Title of Change:	MT9V124 Datasheet Update
Effective date:	23 May 2018
Contact information:	Contact your local ON Semiconductor Sales Office or <Sonya.Yip@onsemi.com>
Type of notification:	This Product Bulletin is for notification purposes only. ON Semiconductor will proceed with implementation of this change upon publication of this Product Bulletin.
Change category:	☐ Wafer Fab Change ☐ Assembly Change ☐ Test Change ☒ Other Documentation
Change Sub-Category(s):	☐ Manufacturing Site Change/Addition ☐ Material Change ☒ Datasheet/Product Doc change ☐ Manufacturing Process Change ☐ Product specific change ☐ Shipping/Packaging/Marking ☐ Other: _____
Sites Affected:	ON Semiconductor Sites: None	External Foundry/Subcon Sites: None

MT9V124 Datasheet Changes

Table 19. PACKAGE DIMENSION

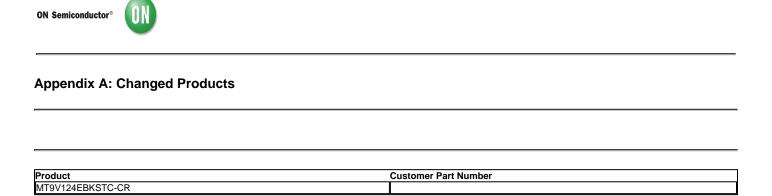
2. Remove Table 19

a. Dimensions in table 19 correspond to the old package drawing format

b. Package dimensions are now located in the ON Semi formatted CASE 570BN ISSUE A (package drawing)
